Technical Advisory Notice: UPDATE - e2s Upper Impinger Plate Replacement

01/03/2022 TA#010322

This is an update to our previous Technical Advisory TA#011020 dated, 6 Oct 2020.

fig.1 **PSB3168**

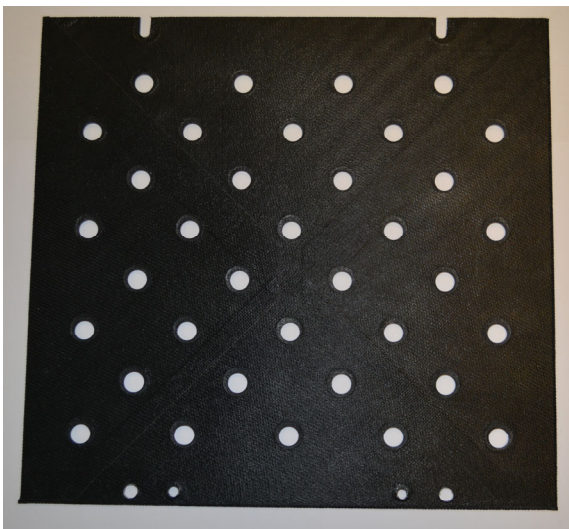
With the introduction of the e2s V2 Oven from July 2021, identified by the 12th digit now being '2' in the SKU and Serial No starting. Example **210721319xxxx** and **e2SDBMV5BDL2CLEU**
There are now distinctly two different styles of Upper Impinger Plate, the original PSB3168 – PTFE Wrapped Impinger and the new DY0108 – Upper Impinger Plate for the e2s V2 [see below for reference].

Any e2s serial number **before** July 2021 [210721309xxxx] replace with PSB3168.
